NEBRASKA ARMY NATIONAL GUARD SIDNEY RC INTERIOR SUSTAINMENT (REBID)

PROJECT NO. 31030399

A D D E N D U M N O . 1

Project: Sidney RC Interior Sustainment
#310399 (REBID)

DRAWING TITLE:
ROOF PLAN - POWER

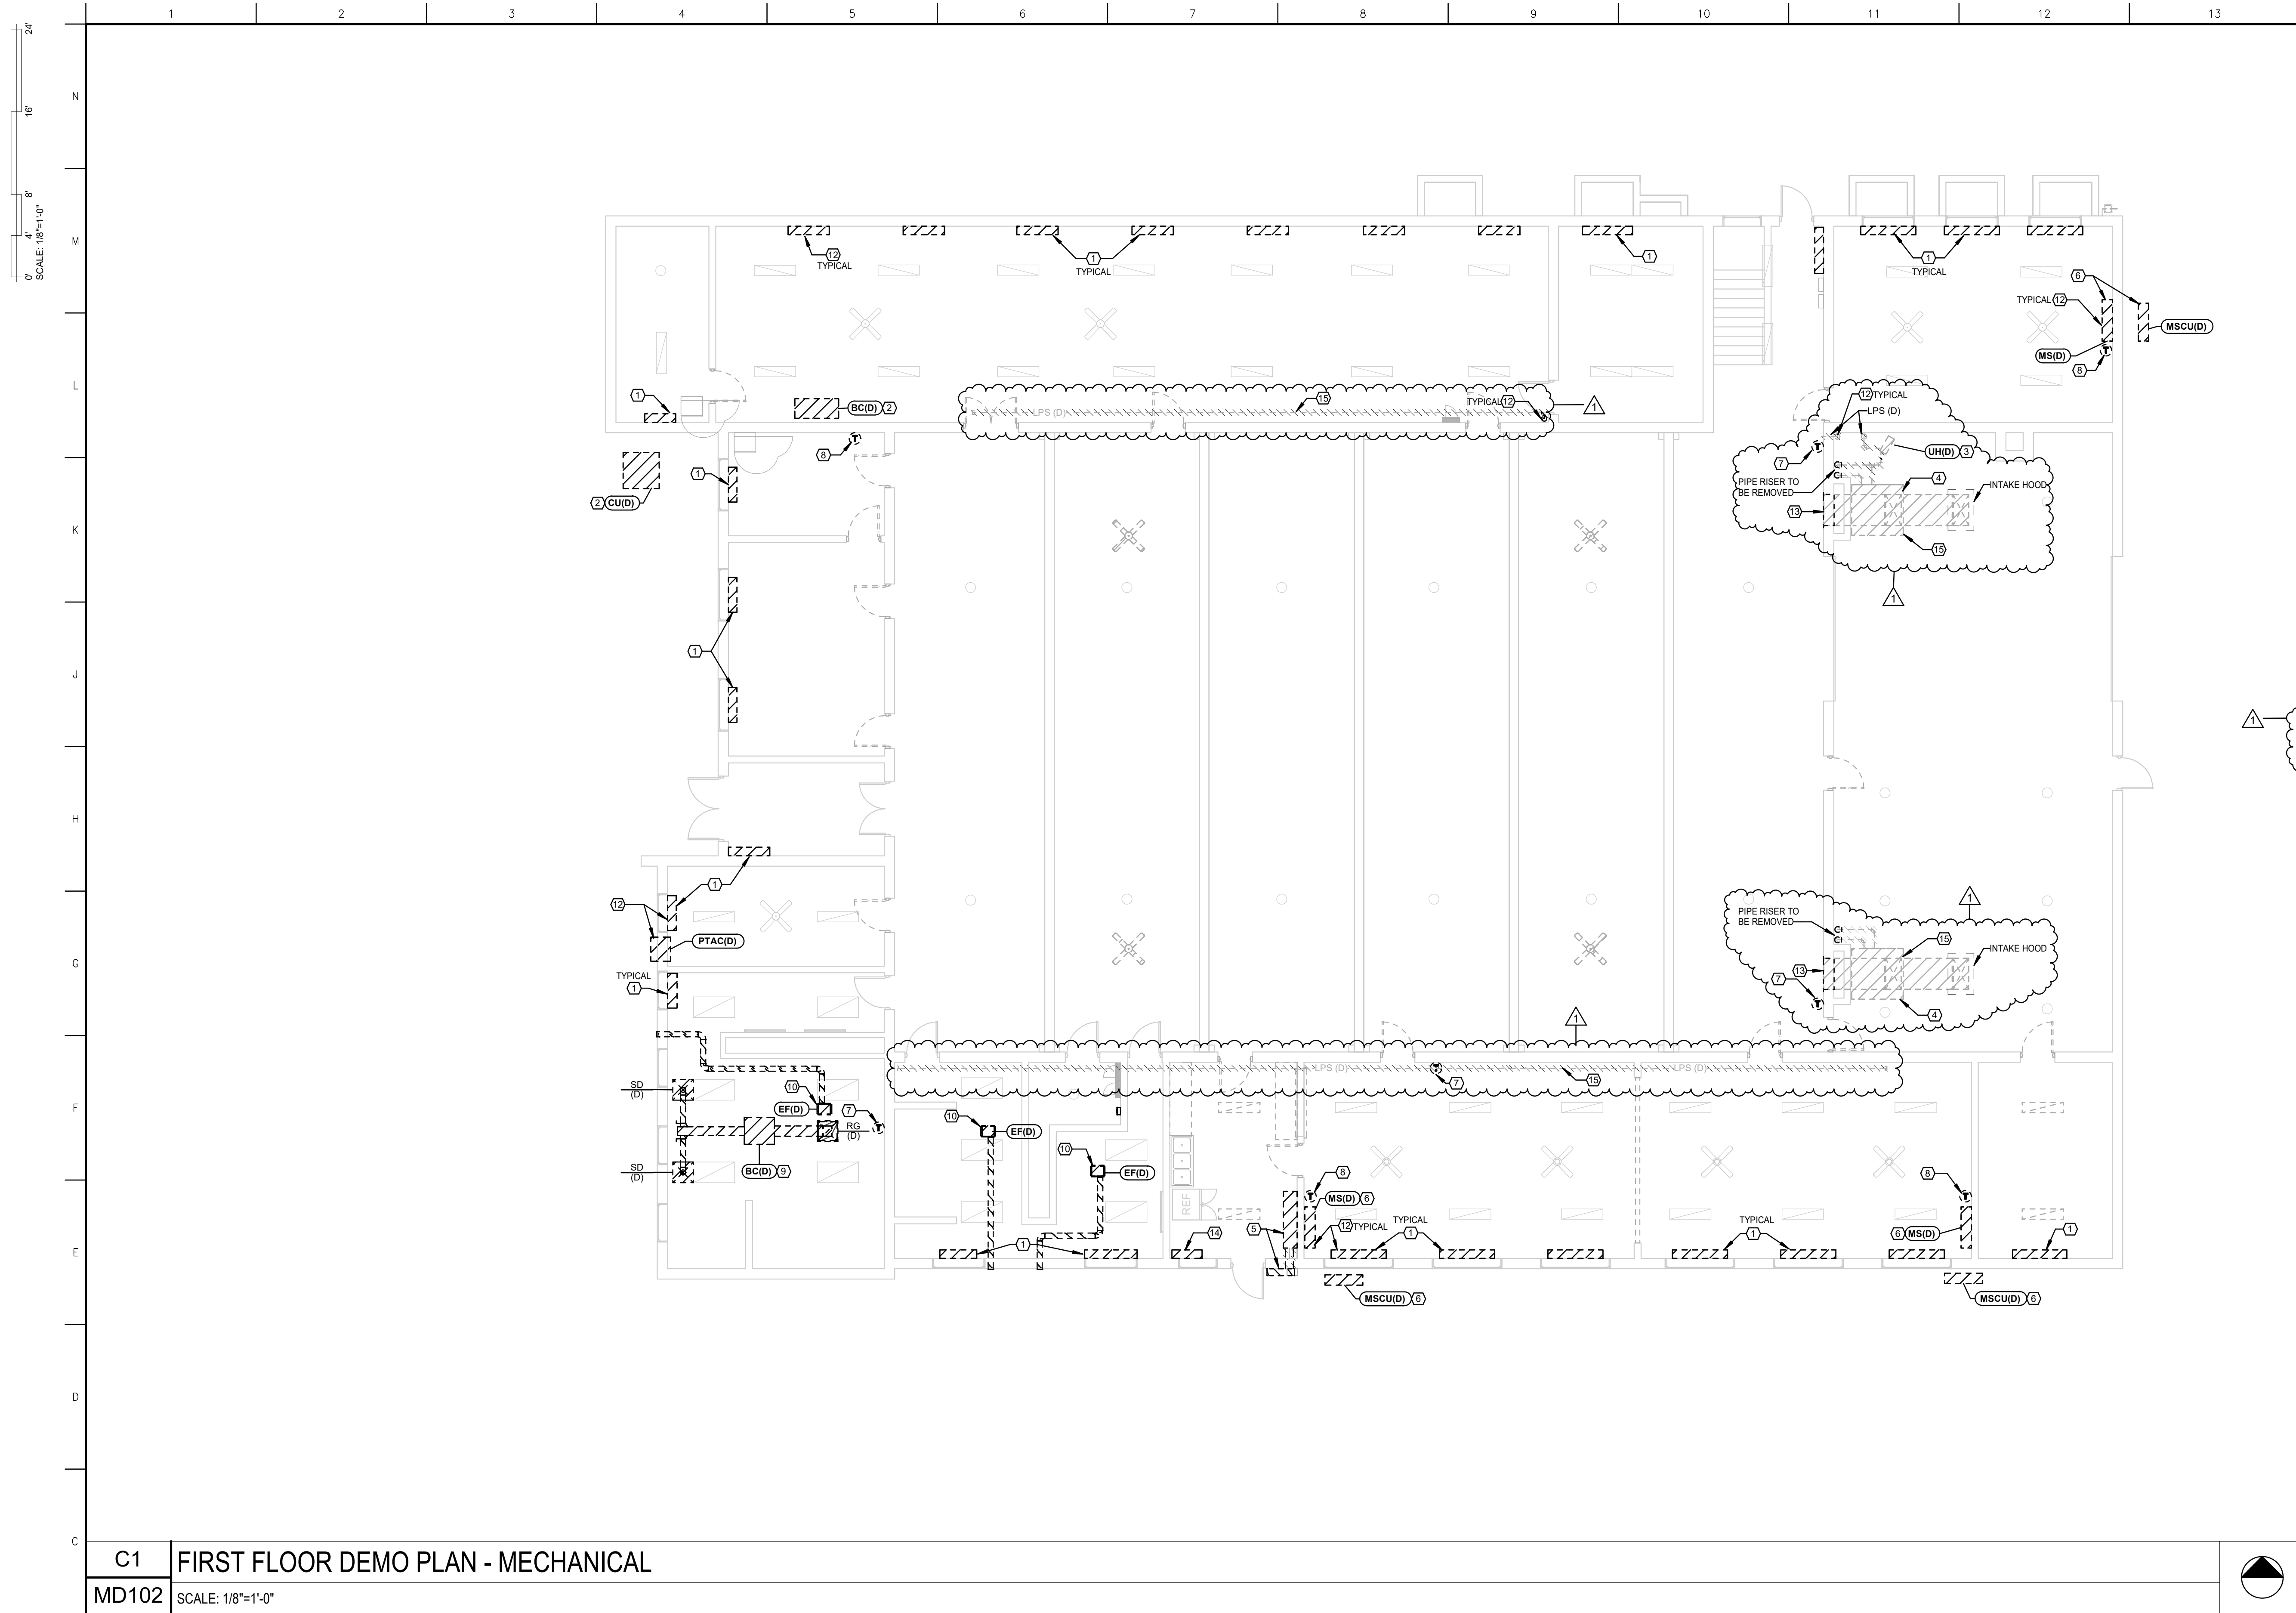
Sheet E203 – Roof Plan – Power

1. Relocated RTU disconnects to exterior gymnasium wall.
2. Removed unistruts from plan and removed keynote #2.

DRAWING TITLE:
FIRST FLOOR DEMO PLAN -
MECHANICAL

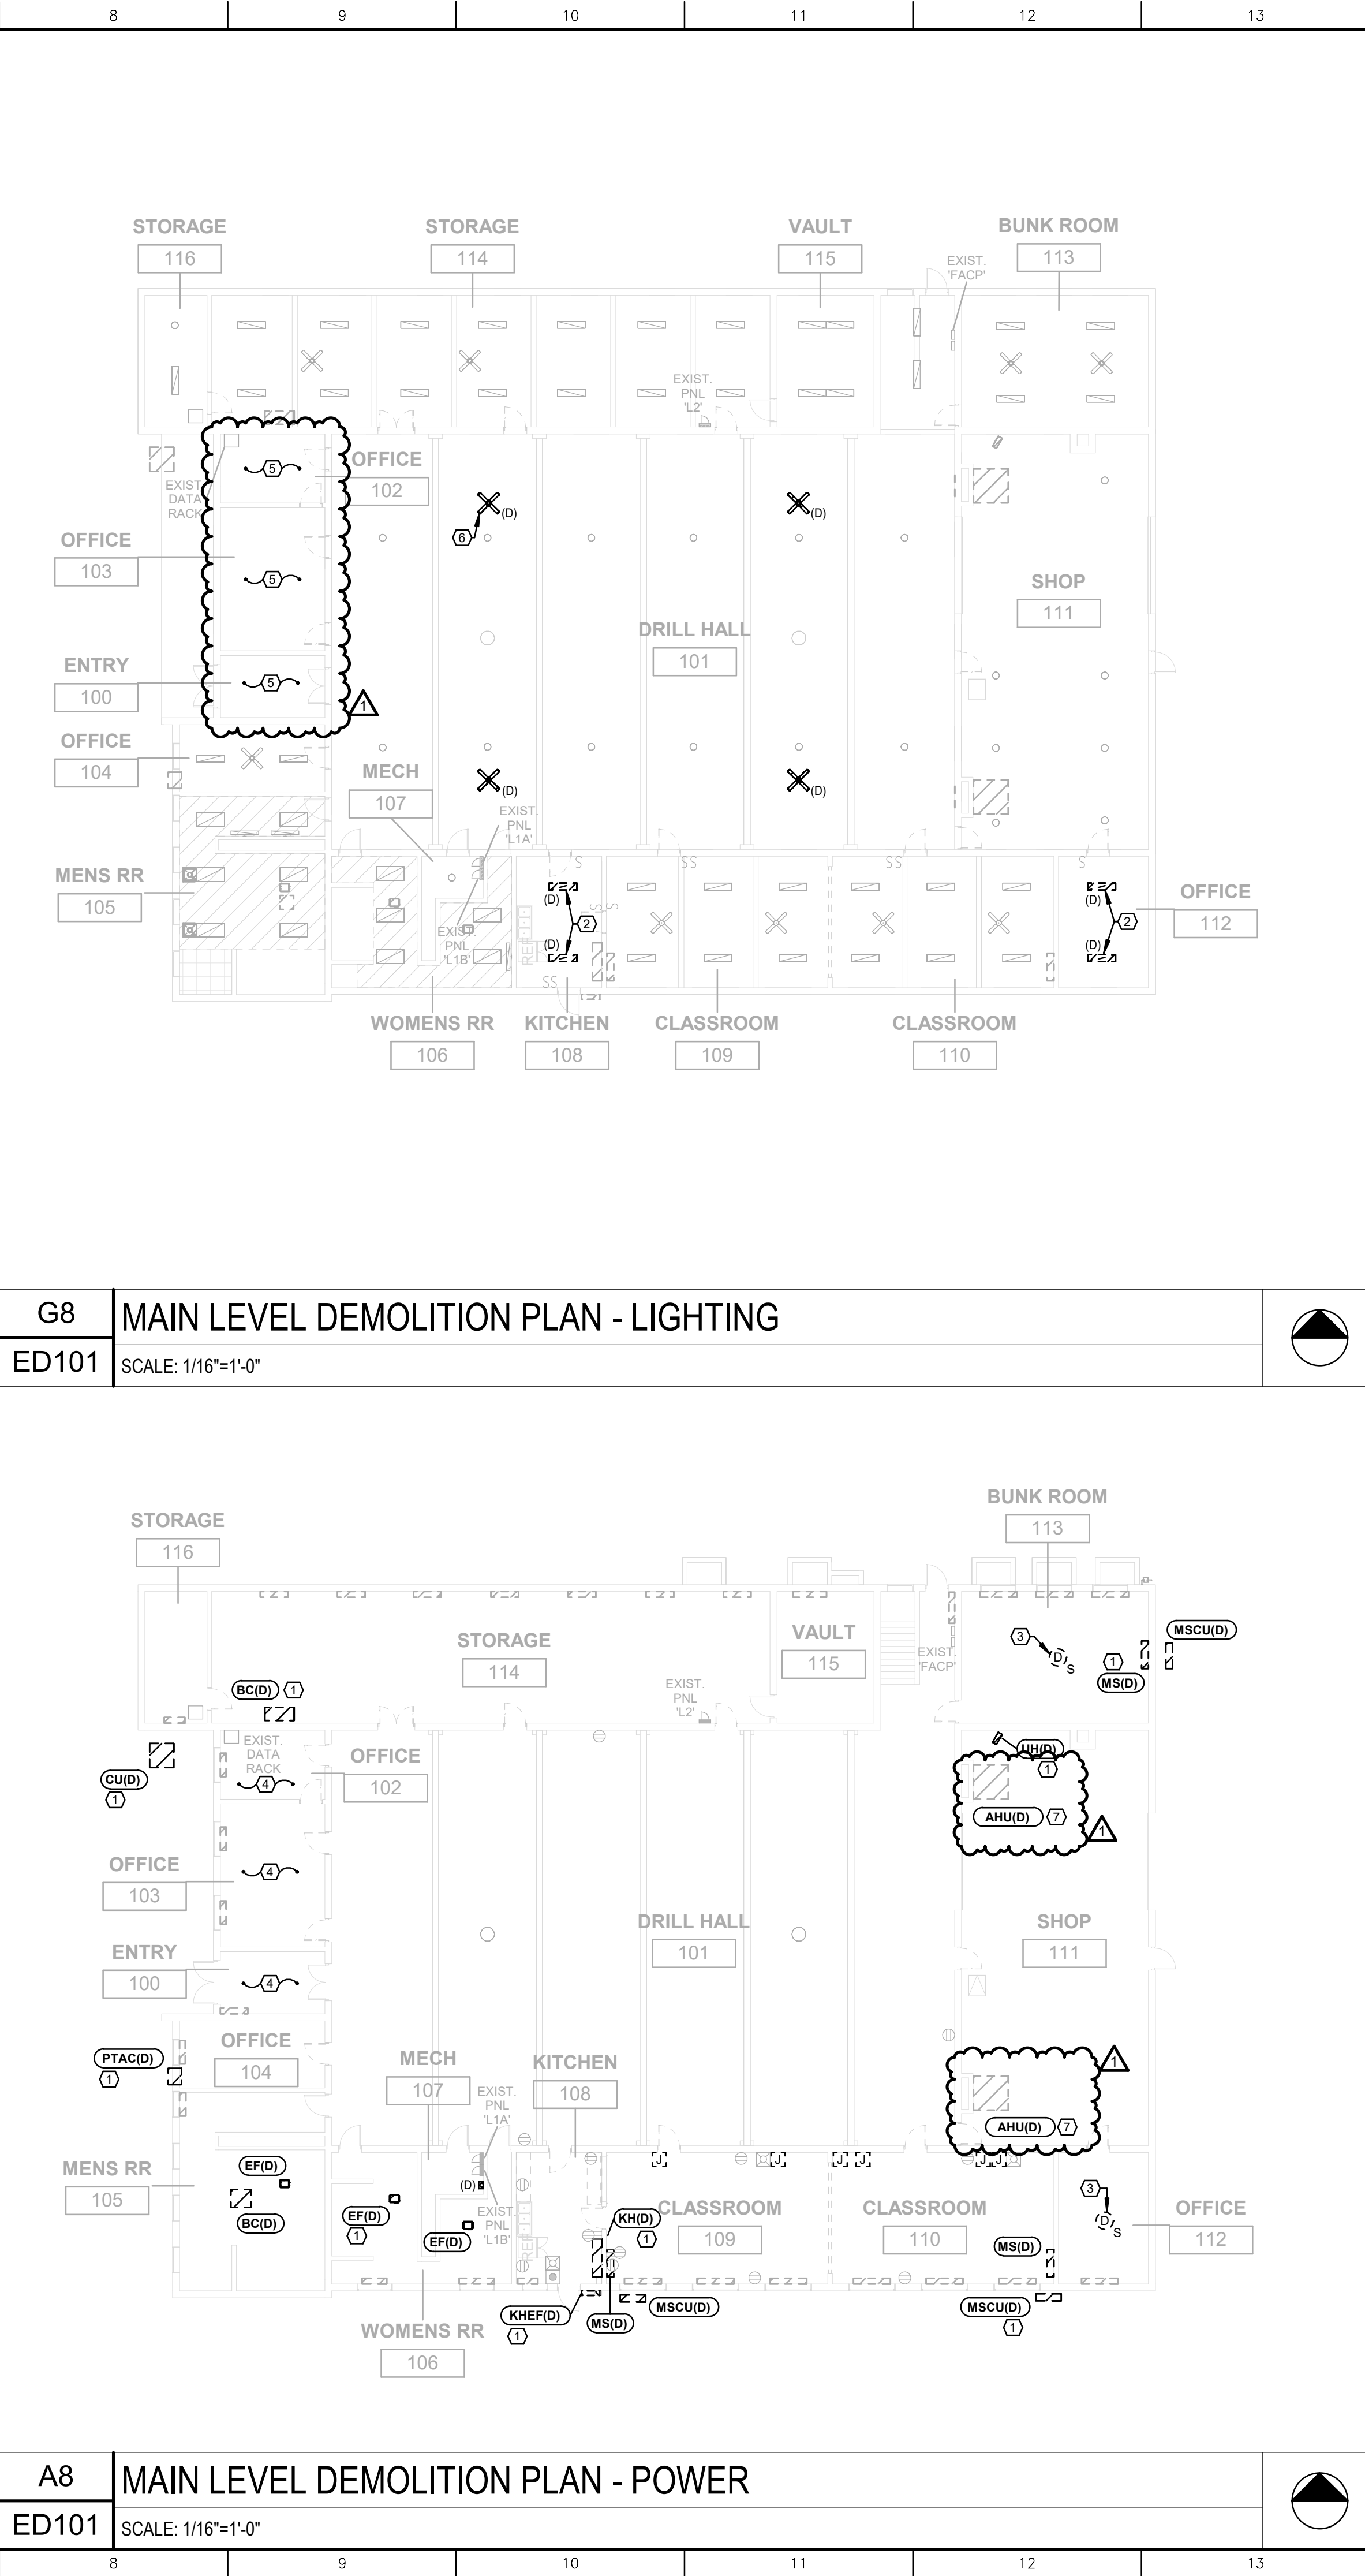
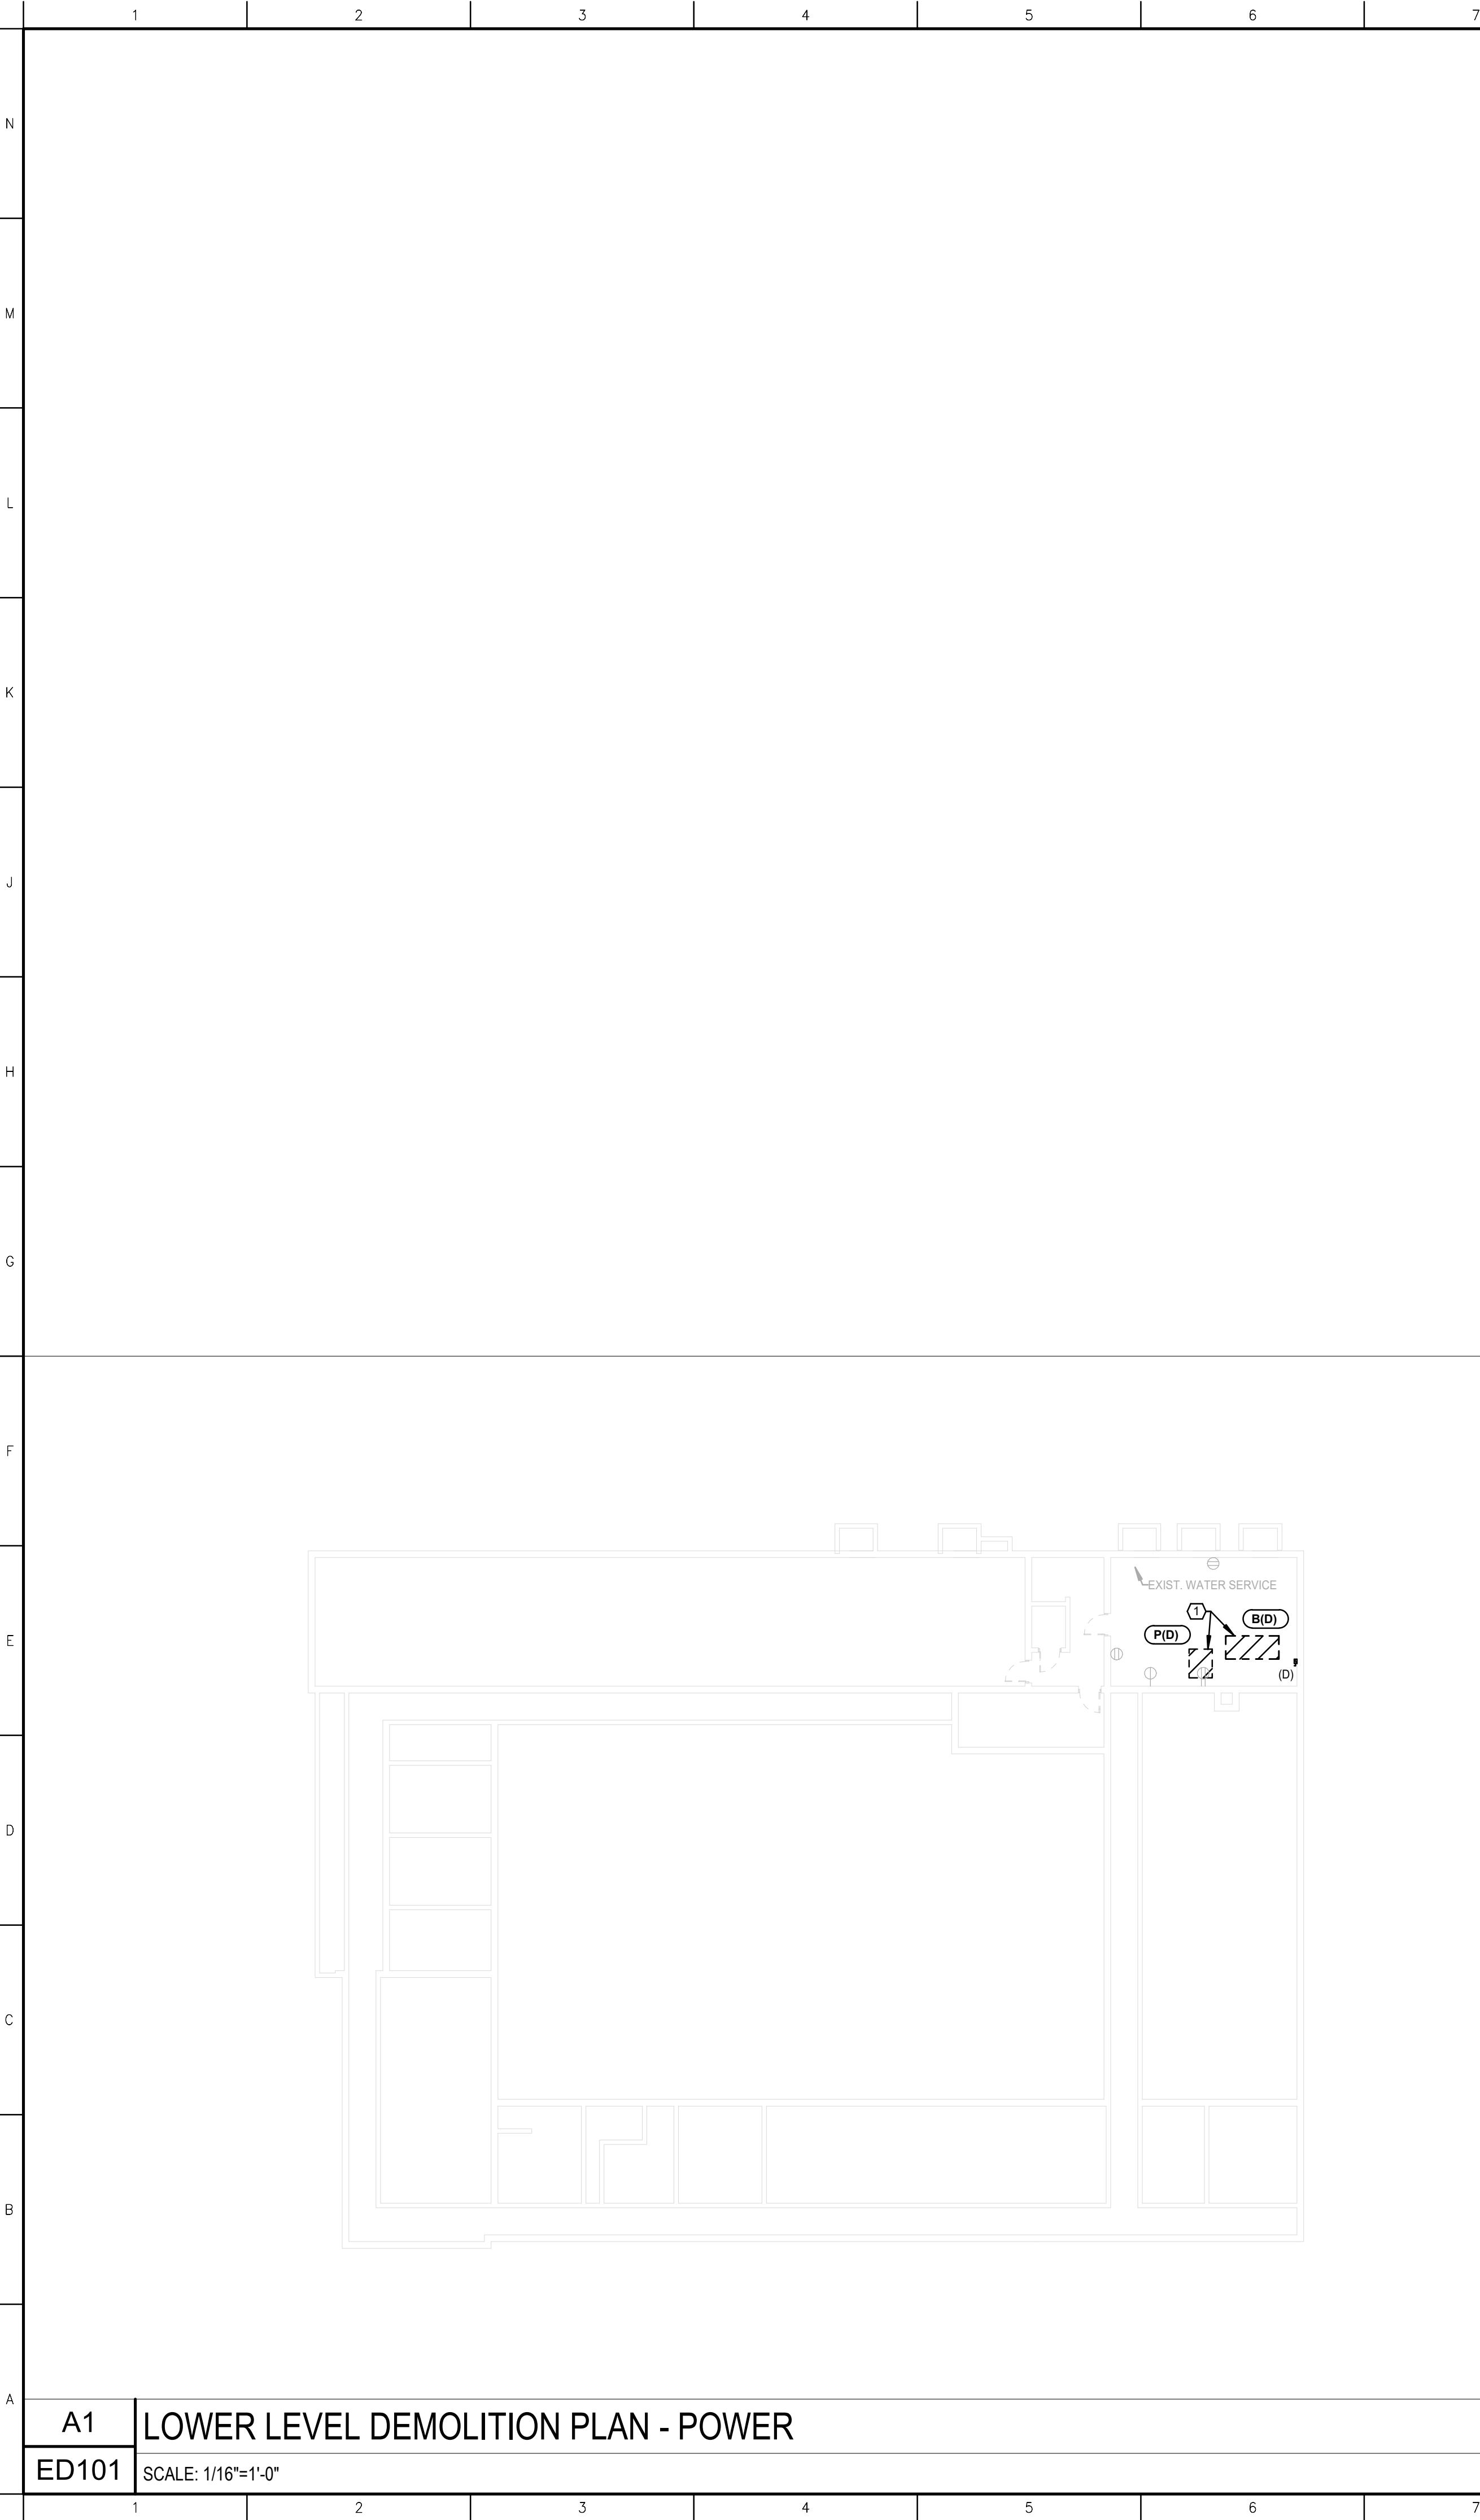
DRAWING REVISIONS**Mechanical – See Revised Drawings for More Information****Sheet MD 102 – First Floor Demo Plan - Mechanical**

1. Existing steam piping in Classrooms 109 & 110 and Storage 114 originally shown to be removed has already been removed by the Owner as part of a previous asbestos abatement project. Keynote 15 has been added to the drawings to clarify that this work is no longer part of the current project scope.

2. Existing air handling units (AHUs) and associated ductwork located in Shop 111 originally shown to be removed have already been removed by the Owner as part of a previous asbestos abatement project. Key Note 15 has been added to the drawings to clarify that this work is no longer part of the current project scope. The Contractor shall remain responsible for removing the existing vertical steam piping attached to the wall that previously served the AHUs.

3. Newly added Keynote 15 to read "EXISTING EQUIPMENT/STEAM PIPING SHOWN FOR DEMOLITION HAS BEEN REMOVED BY OWNER UNDER A SEPARATE ASBESTOS ABATEMENT CONTRACT. NO DEMOLITION OF THESE ITEMS IS REQUIRED."
